IMPORTANT!

TECHNICAL SERVICE BULLETIN

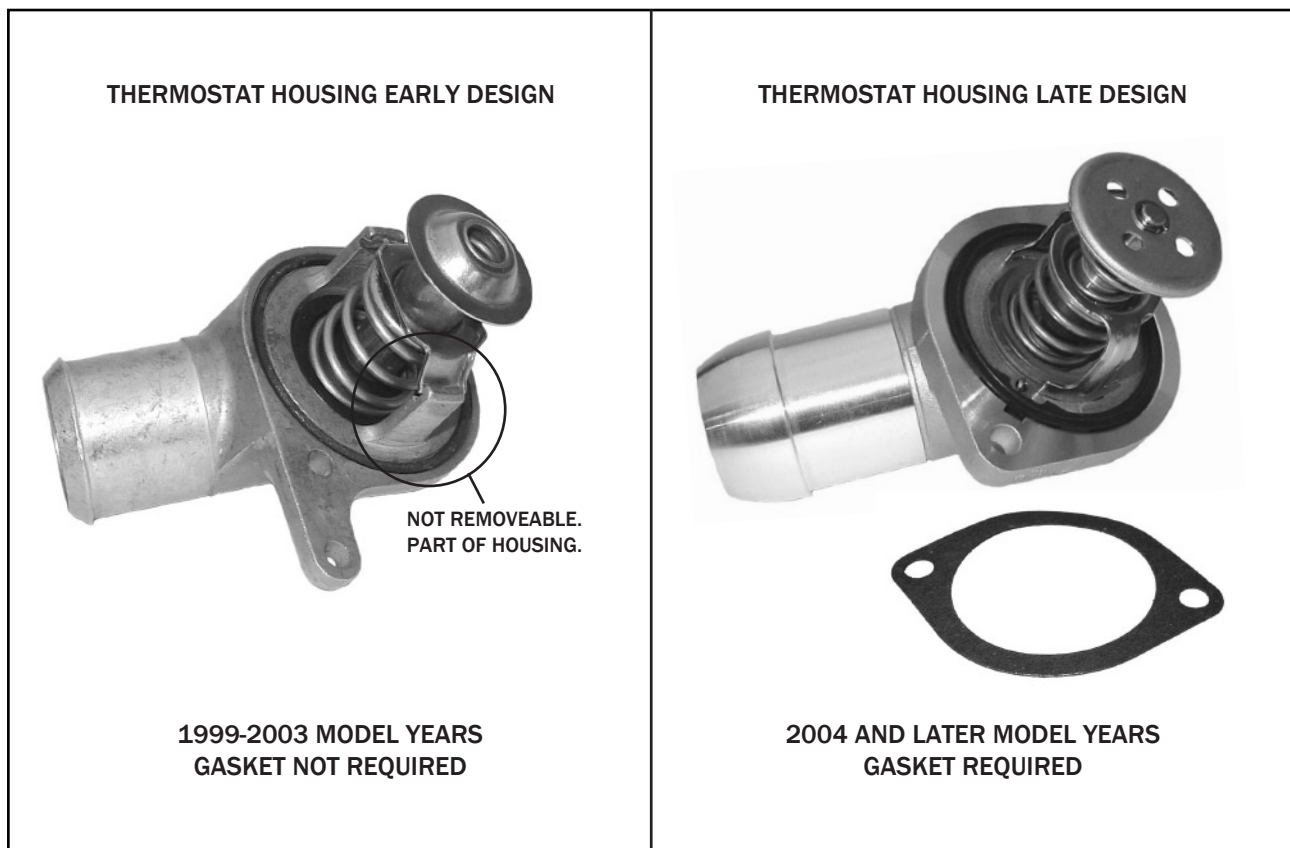
When installing this water pump on model years 1999-2003, the gasket contained in this kit is not required for sealing the pump to the thermostat housing. This is due to the design of the thermostat housing's mounting surface (See Early Design photograph). For model years 2004 and later, the gasket contained in this kit is required for properly sealing the pump to the thermostat housing (See Late Design photograph).
